Safety Evaluation Report

related to the operation of
Midland Plant,
Units 1 and 2

Docket Nos. 50-329 and 50-330

Consumers Power Company

Figure 2.9 Service water pump structure underpinning plan and sections (Source: Pechtel drawing C-2035, Revision 2, provided to staff during staff audit on July 27-30, 1982; preliminary drawing not approved by applicant; issued for information only)

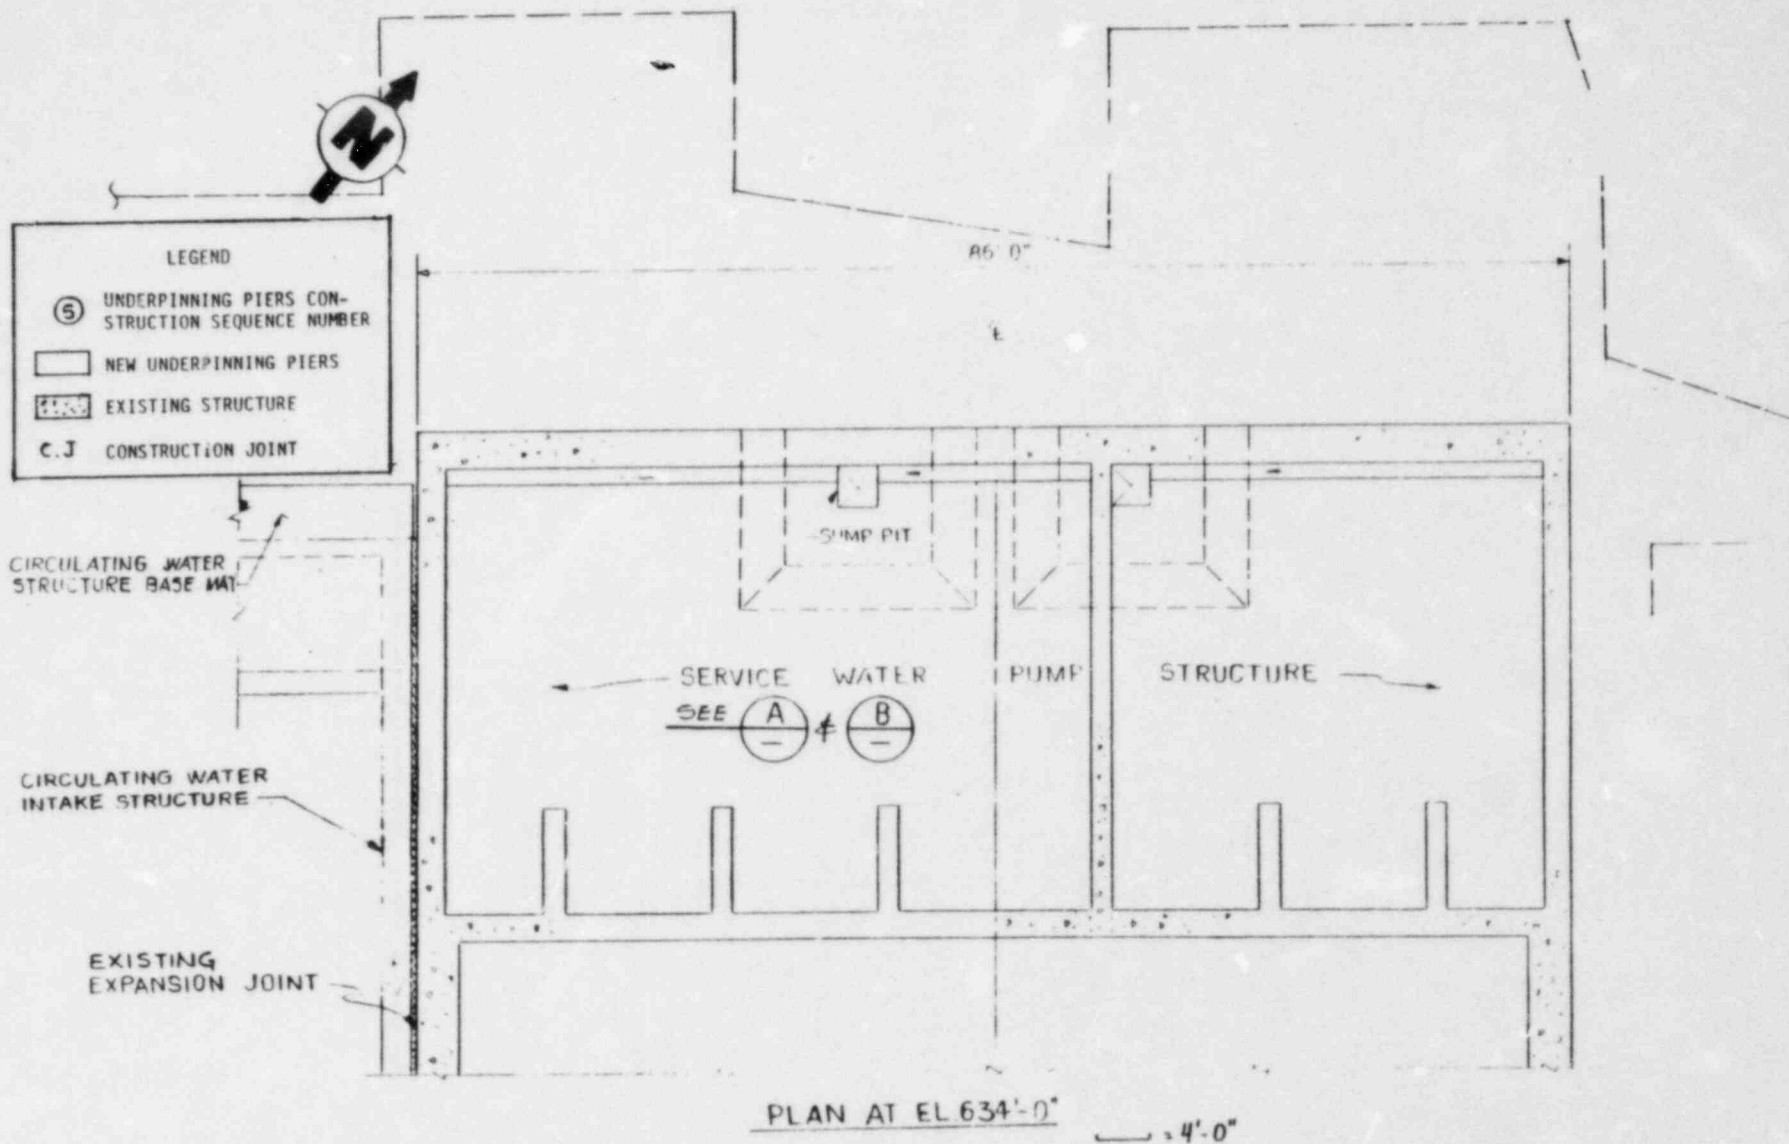
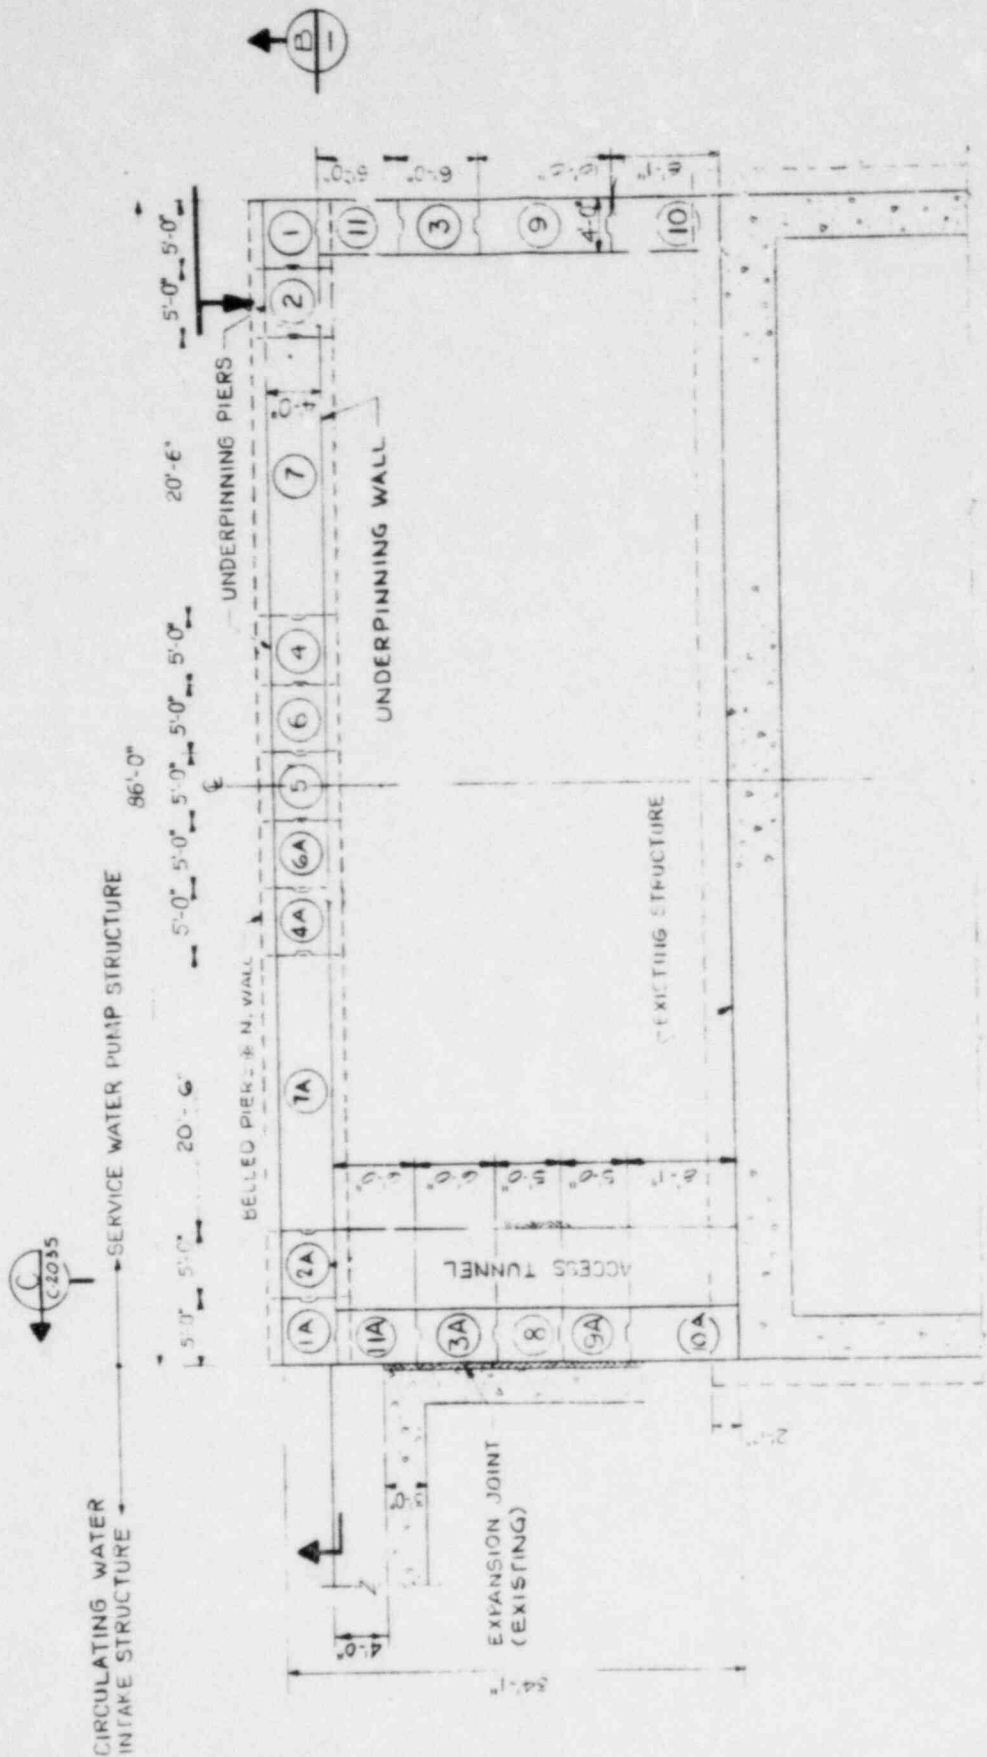
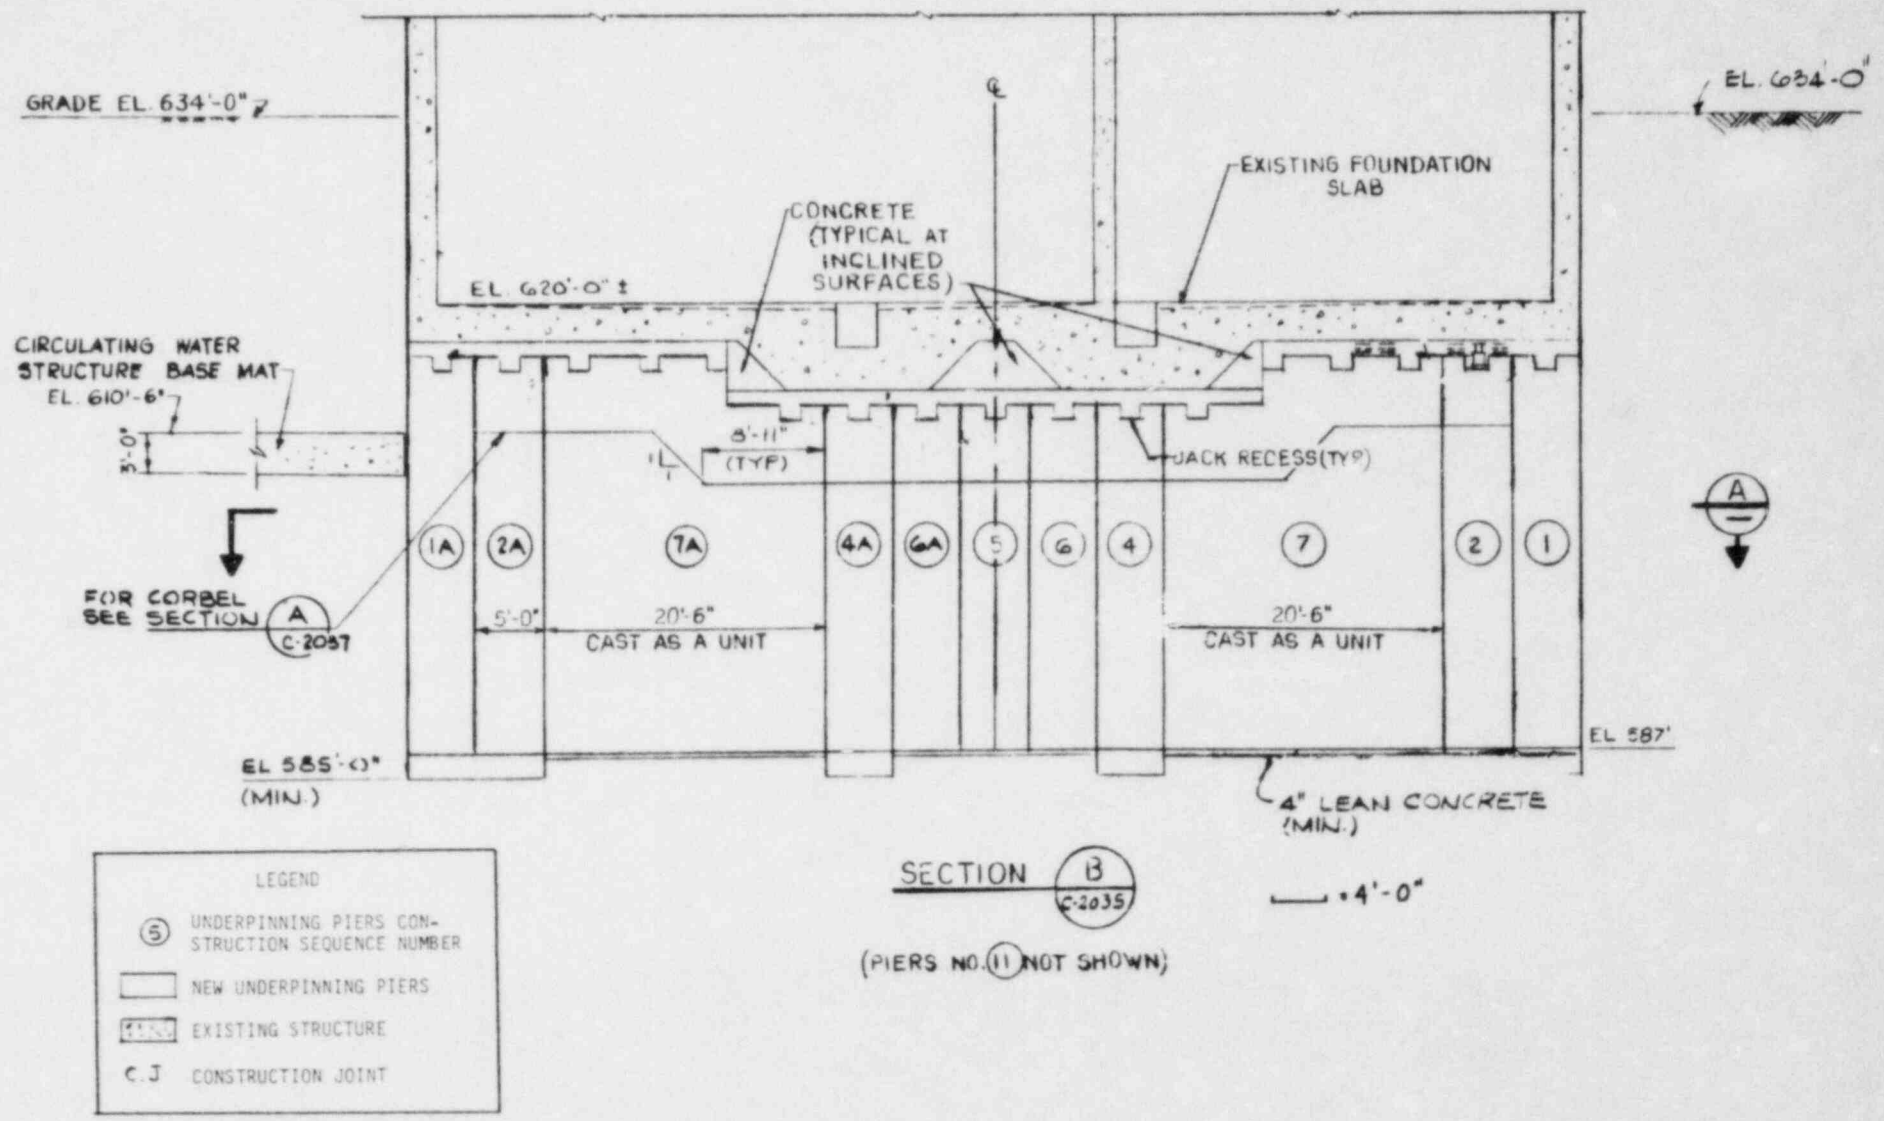
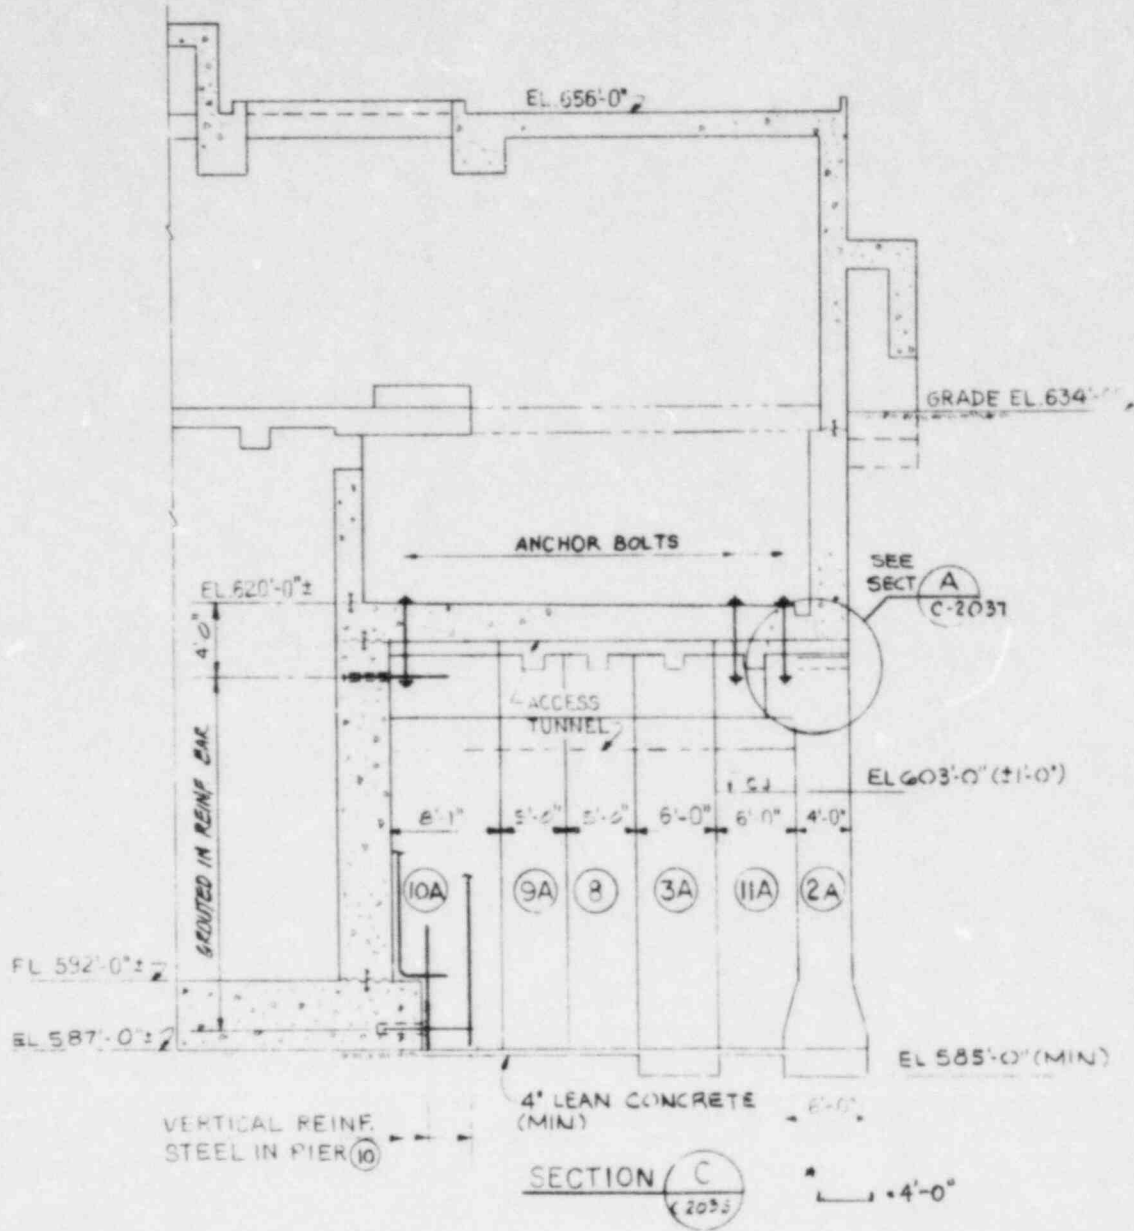
The proposed new permanent underpinning wall beneath the north portion of the SWPS will extend through the fill to at least el 587 ft, which is the same bearing level as the existing deeper portion. Plan and section views of the underpinning are presented in Figure 2.9 of this SSER. (As shown on Figure 2.9, the SWPS and CWIS actually face northwest; however, for ease of discussion, the text throughout this SSER assumes they face north.)

The remedial action for the SWPS generally consists of installing a permanent, continuous underpinning wall under the foundation of the overhang portion of the structure (see Figure 2.9 of this SSER). The wall transfers the loads of this part of the structure through the fill to the competent undisturbed natural foundation soils. The wall is connected to the existing structure. The sequential numbering of the wall's underpinning piers as shown on Figure 2.9 coincide with the actual construction sequence that will be followed to complete the SWPS underpinning work.

The final jacking loads are applied after No. 10 piers (see Figure 2.9) are constructed and the underpinning wall has progressed to within 6 ft of the vertical interface with the existing structure. Settlements caused by this load are monitored. When the resident geotechnical engineer determines that the settlement has decreased to a predetermined rate, the load is transferred from the jacks to wedges positioned between the top of the piers and the underside of the overhang, and the jacks are removed. The No. 11 piers are poured, encasing dowel bars that were previously drilled and grouted into the vertical face of the existing structure, thereby connecting the underpinning wall to the existing structure. The space between the top of the underpinning wall and the underside of the base slab is filled with nonshrinking grout, and previously placed anchor bolt assemblies are tightened. The underpinning wall is connected to the structure at both the vertical and horizontal interfaces. The No. 12 piers are then constructed, completing the underpinning wall.
